Model	FX6			Date of Modification
Modified Article	FDU			Execution Date
Reason for Modification	Parts catalog correction Vender change The PWB has been changed. Refer to the attached components list.	standards () dardization	To facilitate assembly To improve reliability Other	After the old parts have become out of stock.
Old Part No. Nev	w Part No. Description	Q'ty Used Old → New	Interchange- ability	Remarks Parts Catalog Index No. Page
H5166003N H	5166043 PCB-FDU - US	1 → 1	0/0	11 3
H5166005J H	5166045 PCB-FDU - EU	1 → 1	0/0	11 3
				M. Iwasa Manager 2nd T.S.Sec. Int'l Marketing Group

P/N: H5166003 → H5166043

MODIFICATION BULLETIN NO. F/L Series-005

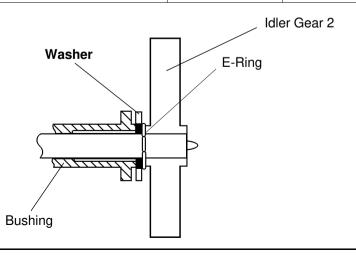
Model	FX6	Date of Modification
Modified Article	Development Unit	Execution Date
Reason for Modification	Parts catalog correction Vender change To meet standards (Part standardization To facilitate assembly To improve reliability Other	From June production in 1995.
	 Part number correction for the Gear. A washer has been added between Idler Gear 2 (index no.58 of page 13 in the parts catalog) and Bushing (index no.63 of page 13) to reduce noise from the development unit.

Old Part No.	New Part No.	Description	Q'ty Used	Interchange-	Remarks	Parts Cata	alog
Old Falt No.	New Pail NO.	Description	$Old \to New$	ability	nemarks	Index No.	Page
H5162405C	H5162405D	Rubber Roller Ass'y - DVLP-A4	1 → 1	0/0		5	13
	H0412257	Washer - M5.2 x 0.4	(1→2)				
H5152451	H5152550	Gear - Z18	1 → 1	0/0		2	13

DETAILS OF MODIFICATION

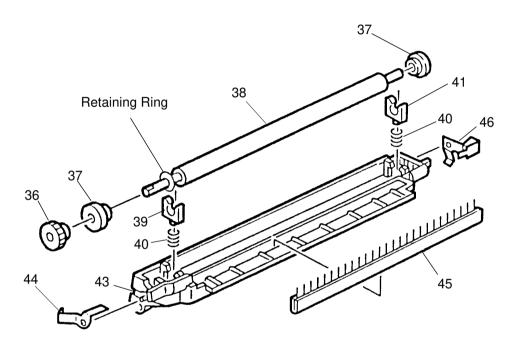
Model	FX6				Date of	Date of Modification		
Modified Article	Development Unit				Exec	Execution Date		
Reason for Modification	Parts catalog Vender chang A retaining ring fo See the next page	ge r the Transfer Roller v	Part standardization	To facilitate asser To improve reliab Other		t has become out of		
Old Part No. Ne	ew Part No.	Description	Q'ty Used	Interchange-	Remarks	Parts Catalog		
Old Part No. Ne	w Fait No.	Description	$Old \to New$	ability	neillaiks	Index No. Pag		
H5162419 H	H5162404 Transfe	er Roller - A4	1 → 1	O / O (*)	See next page	38 1-1		
H5162431 H	H5162498 Guide	- Transfer Roller	1 → 1	O / O (*)	See next page	43 1-12		
					M. Iwasa Manager 2nd T.S.Sec. Int'l Ma

38: Transfer Roller - A4 43: Guide - Transfer Roller

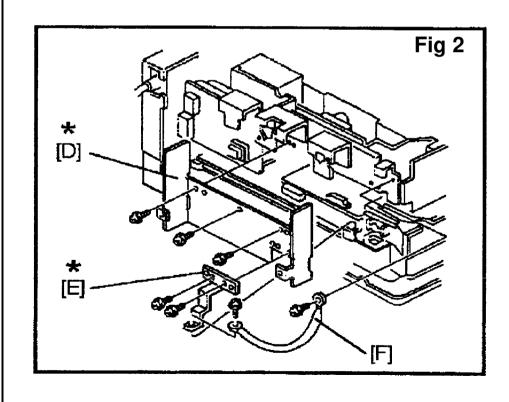
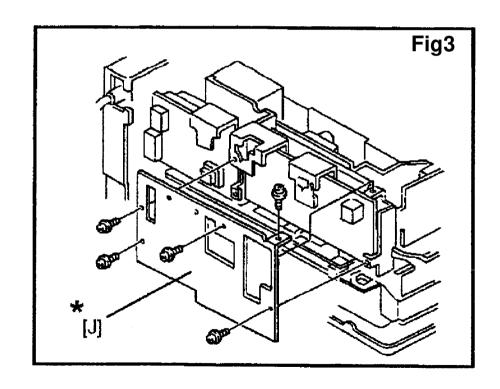
N	Model	FX	K4 (Europ	e and Asia only)				Modif	ication	
Modif	fied Artic		•							
Reason for Modification Parts catalog correction Vender change Parts standards () To facilitate assembly To improve reliability Other To meet the CE Mark standards, some parts have been added for Europe and Asia models.						ility	From 1st production.			
Old Pa	ırt No.	New P	Part No.	Description	Q'ty Used Old → New	Interchange- ability	R	emarks	Parts Cat	
(H515 -	30, 40, 4	3, 51, 59	, 60, 80)							
		1607	70576	Magnetic Core	0 → 1		* added in * for PSTN	to accessary box // Cable		
		XXXX	XXXXX	Instruction Manual of Core	0 → 1					
H515	5600	H515	5600A	PCB - PSU - 220V	1 → 1	X/O			21	1-4
		H515	5 5322	Inlet - PSU	0 → 1		n	nissing	13	1-23
		1607	70278	Magnetic Core	0 → 11		See the	attached sheet		
		1607	70492	Magnetic Core	0 → 1					
(H	130 - 56:	 	DD)							
H515 5			5 5358	HDD Harness - 44P	1 → 1	X/O			3	1-35
RC	RE *	ASIA *					2nd Fie QA Div	al Manager eld Information Dep	oartment

Old Parts No.	New Parts No.	Description	Q'ty Used	Interchange-	Remarks	Parts Cat	alog
Old Parts No.	new Parts No.	Description	$\mathbf{Old} \to \mathbf{New}$	ability	nemarks	Index No.	Page
(H143 - 14: ISDN Kit)							
	H515 3183	STAY - G4	0 → 1		[J] in Fig 3.		
	H515 3184	STAY - G4 - 2	0 → 1		[D] in Fig 2.		
	H515 3186	GROUND PLATE - G4	0 → 1		[E] in Fig 2.

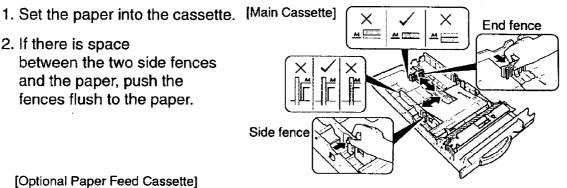
When you set paper in the cassette, please note the following:

2. If there is space between the two side fences

and the paper, push the fences flush to the paper.

* Fusing Unit - 115V (H516 2100)

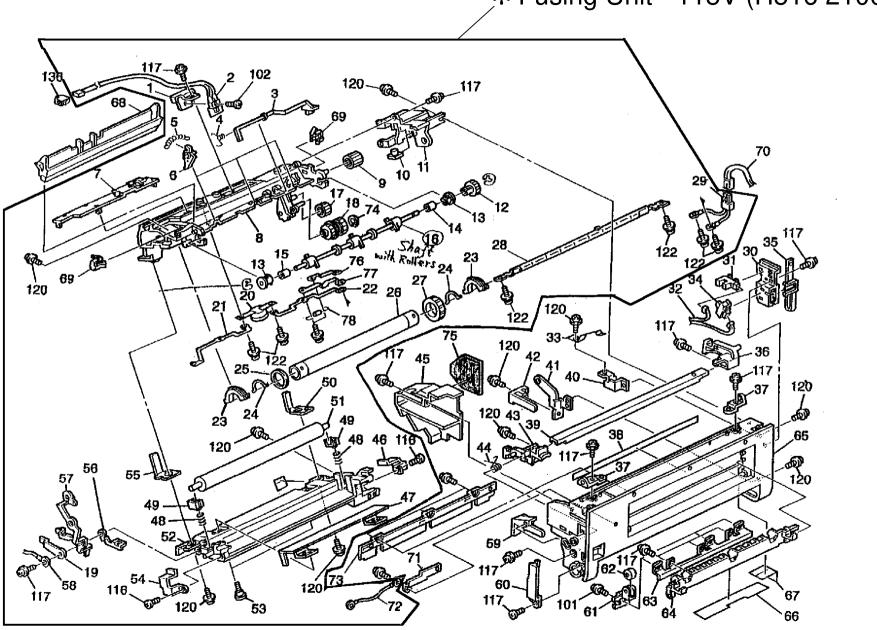
Model		FX4, FX6, F	X6MKII, FX6CI	D (115V for North	America)				Modificati	on Schedule	
Modified Articl											
Reason for Modification		∐ Vend	catalog correct er change lequested by Ol	ion MNI FAX (See the	To meet sta Part standa attached she		To facilitate asser To improve reliab Other(New part re	oility			
Old Part No.	Nau	/ Part No.		Description		Q'ty Used	Interchange-		emarks	Parts Cata	alog
Old Part No.	ivev	Part No.		Description		$Old \to New$	ability	n	emarks	Index No.	Page
	H5	16 2100	Fusing Unit - 1	15V		0 - 1					
								2nd F	ii ral Manager iield Information Di ivision	epartment	
RC R	RΕ	ASIA									
*								Prepa	ared by Y.Okunishi

1) Rubber Roller

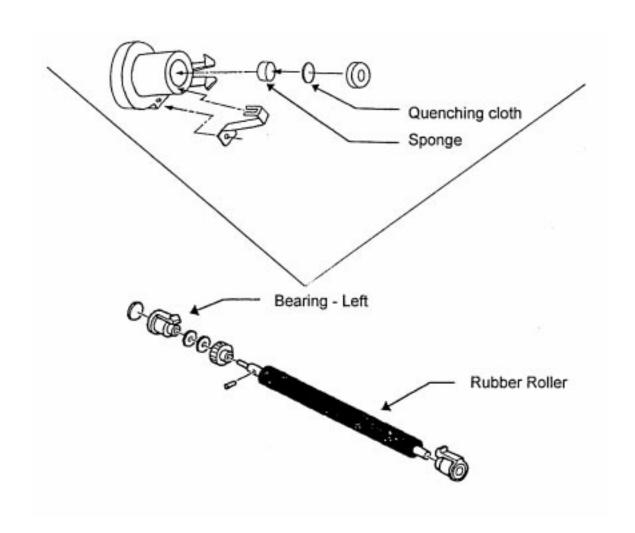
The mold of the rubber roller is changed to a new type which is the same mold as for the other models.

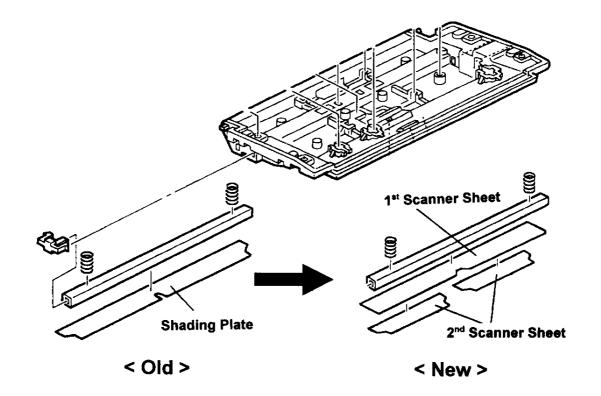
Model: FX6, FR6			Date	e: 22-Aug-0	0	No.: MH515213a	
Modified Article: ADF			Prepared by: Y. Okunishi				
From: Technical Ser	vices Dept., GTS Division						
Reason for Modification:	 □ Parts catalog correction □ To facilitate assembly ☑ Part standardization (with FX4 and FR4) 	☐ Vendor change ☐ To improve reliability ☐ Other		□ To n (neet standards)		
Modification Schedule:	After the old part runs out of s	stock

Old part number	New part number	Description	Q'ty	Int	Page	Index	Note
H5521278		Shading Plate	1-0	O/O	7	19	*
	H5151338	1 st Scanner Sheet	0-1				*
	└─H5151339	2 nd Scanner Sheet	0-2				*

^{*} Interchangeable as a set (H5151338 x 1, H5151339 x 2). The original part number of H5521278 was H5151278.

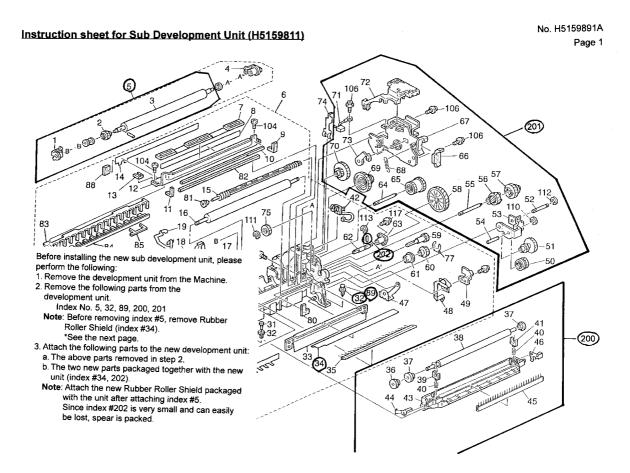
Modified Article: D	Pevelopment unit		Prepared	by: Y. Okunishi
From: Technical Ser	vices Dept., GTS Division			
Reason for Modification:	☐ Parts catalog correction ☐ To facilitate assembly ☐ Part standardization	☐ Vendor change ☐ To improve reliability ☐ Other (For new part		☐ To meet standards ()
Modification Schedule:	The old part (H5159810) w be available at the SPC in			e new part (H5159811) will

Old part	New part	Description	Q'ty	Int	Page	Index	Note
number	number						
H5159810	H5159811	Sub Development Unit – A4	1-1	O/X	-	-	*
H5159811	H5159811A	Sub Development Unit – A4	1-1	0/0	-	-	**

* The new Sub development unit has been registered in the spare part system. The original part number was H5159810 but it has been changed to H5159811. The parts will be available at SPC in January 2001.
